## NORTH COORS SELF STORAGE PHASE 3

GRADING  
AND  
DRAINAGE

C-001

**RE: North Coors Self Storage  
Grading and Drainage Plan  
Engineers Stamp Date None (J10-D013)**

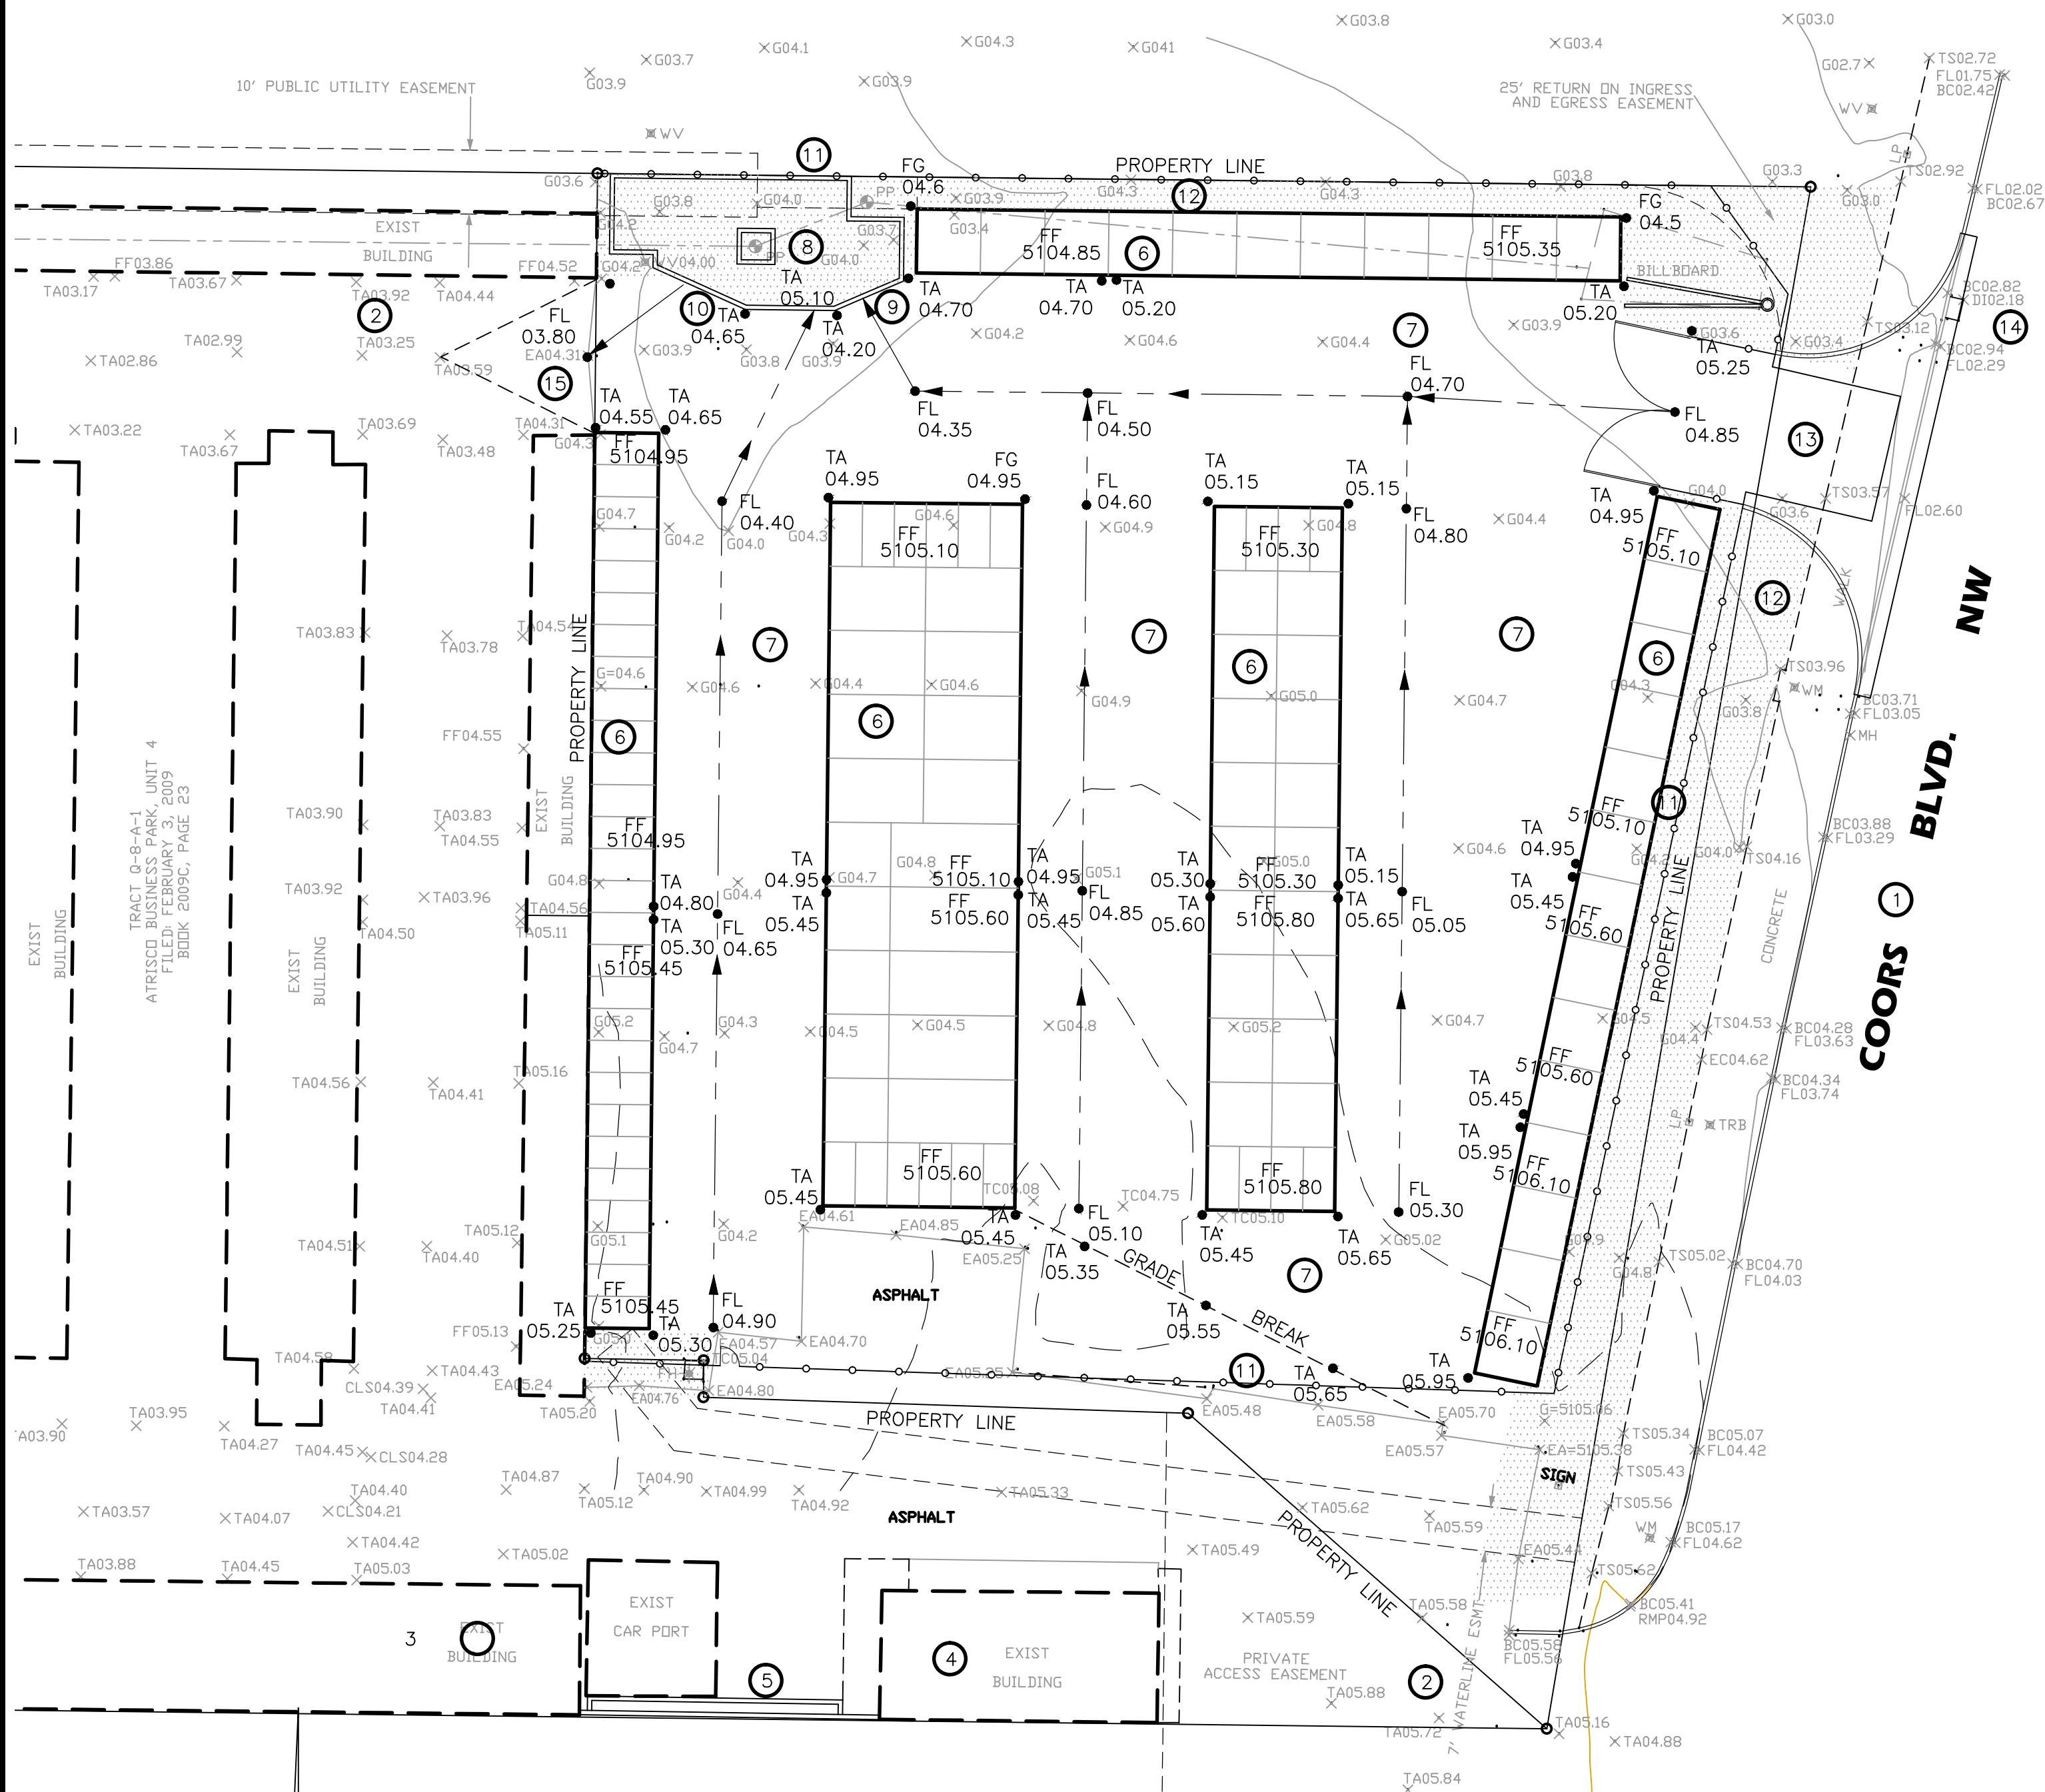
Based upon the information provided in your submittal received 1/29/2015, the above referenced Grading and Drainage Plan cannot be approved for Grading Permit or building permit until the following comments are addressed.

- Provide a PE stamp with date and signature.
- Provide a letter or Email from PNM stating that the First Flush Pond in their PUE is acceptable.
- Provide a letter or Email from NMDOT stating that the removal of the single C catch basin and placing a Double D catch basin in its place, in their roadway is acceptable.
